SERVICE BULLETIN

ENGINE - HP TURBINE ROTOR AND STATOR ASSEMBLY - PROVIDE A NEW STAGE 2 HPT AIR SEAL ASSEMBLY FEATURING RECONTOURED FORWARD AND REARWARD MATING SURFACES AND A TAPERED WEB - CATEGORY CODE 8 - MOD.ENG-72-0207

V2500-ENG-72-0207

Location of the Stage 2 HPT Air Seal Assembly
Fig.2

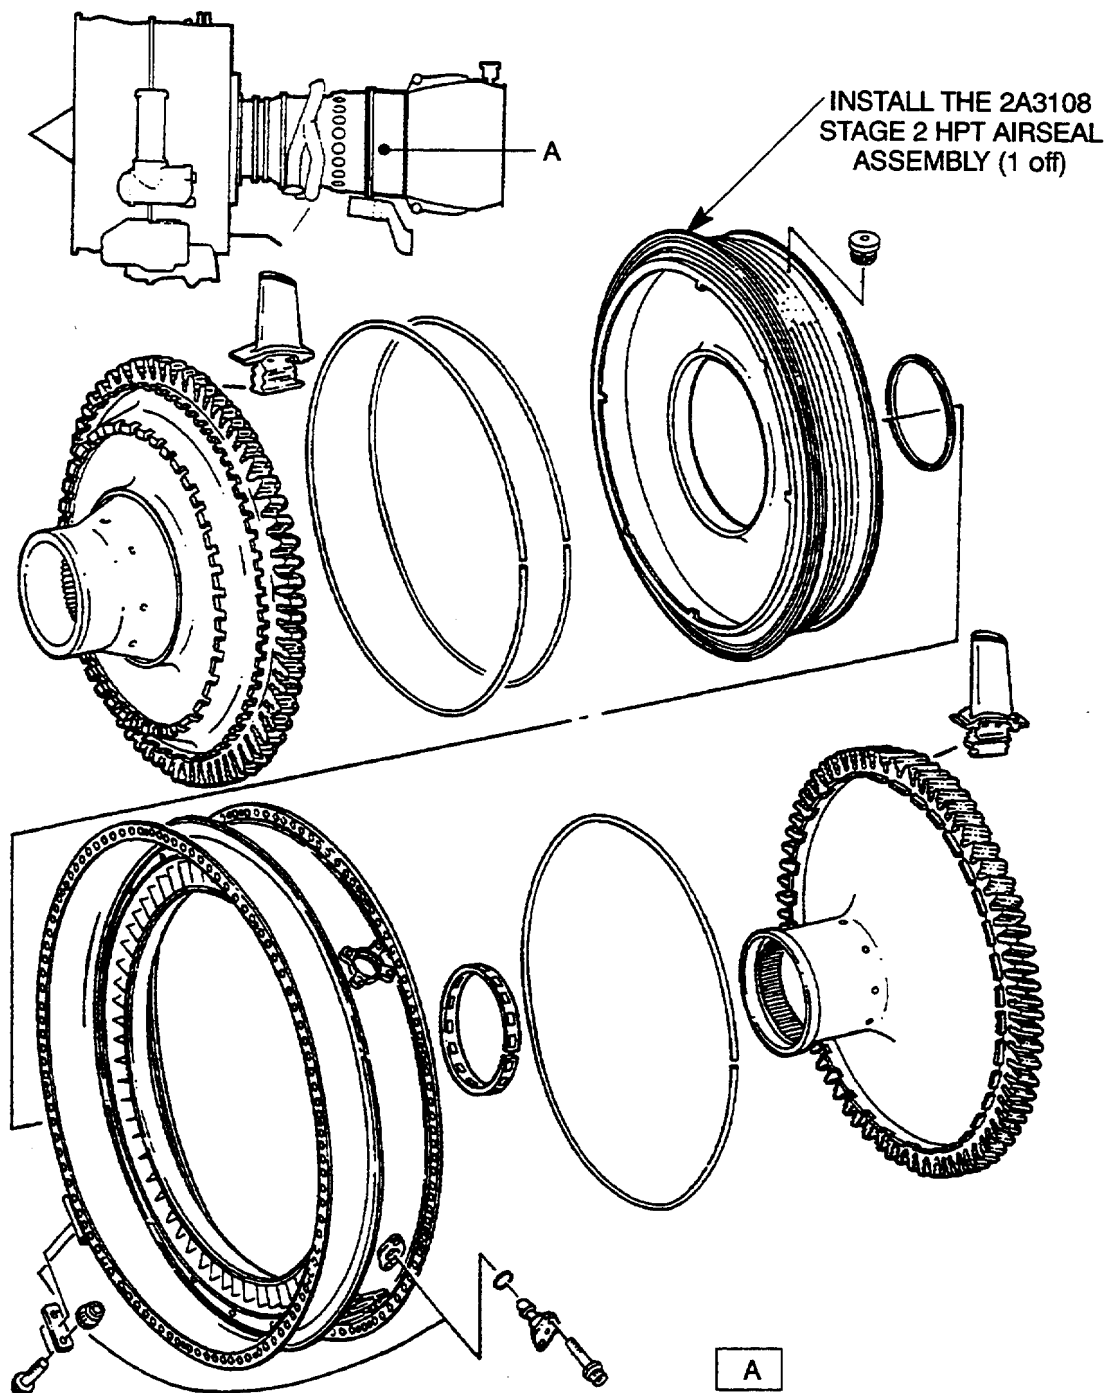
- (1) Install a new Stage 2 HPT Air Seal Assembly that has recontoured forward and rearward mating surfaces and a tapered web.
- (2) For the effect on declared life, See Appendix 1 of this Service Bulletin. The limits given in this Appendix will be included as soon as possible in revisions of the V2500 Engine Manual (E-V2500-1I-A) and the V2500 Engine Manual (E-V2500-3I-A).

- (1) Install the 2A3108 Stage 2 HPT Air Seal Assembly (1 off) by the approved procedure given in Reference (5), Chapter/Section 72-45-00, Assembly (Config-01 or Config-02 for the V2500-A1 and Config-03 for the V2500-A5) and Figure 1.

- (1) Install the 2A3108 Stage 2 HPT Air Seal Assembly (1 off) by the approved procedure given in Reference (6), Chapter/Section 72-45-00, Assembly-01 and Figure 1.
